MEMORANDUM TO PLANNING COMMISSION

DATE: March 5, 2020
FROM: Aaron Smith, Planner II
SUBJECT: PC 20-010 Quayle Hollow Subdivision Redesign

ALTERNATIVE DESIGN

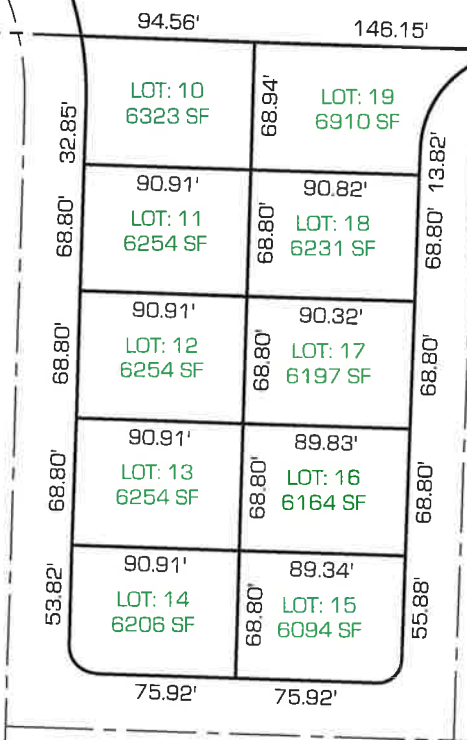
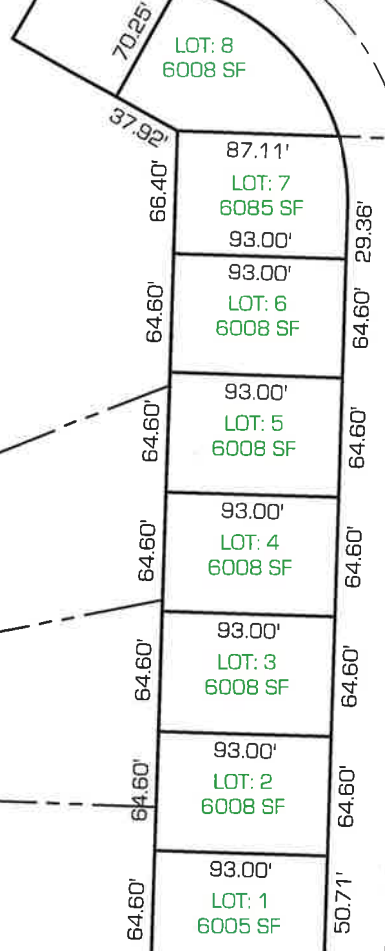
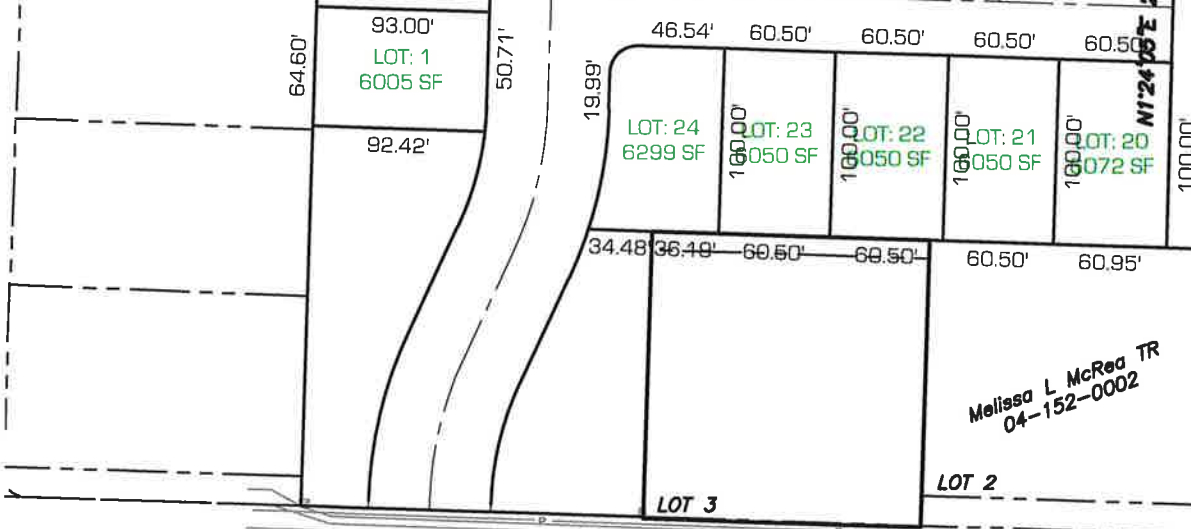
Following continuation of the Quayle Hollow Subdivision, the applicant prepared a redesign of the plat that included 66' and 60' road cross sections throughout the subdivision. The proposal reduces the number of new building lots from 27 to 24, with two of the lots located further north along the 300 W road that connects to Quayle Meadow. The new design also eliminates the north stub and replaces it with a cul-de-sac, and changes the direction of the southern stub to the east. The second stub does not align with any proposed road, but may be able to connect to 200 W to the south of the existing home in the future.

The new design will permit sidewalks, parkstrips, and street trees on both sides of the road; and on street parking. There are 9 lots located along the cul-de-sac and dead-end stub. The LDC permits up to 8 lots before a second connection is required. Overall, for the 24 lots, the LDC requires 3 road connections. Preliminary review of the lot sizes and widths indicate that the 24 lots meet the requirements of the LDC.
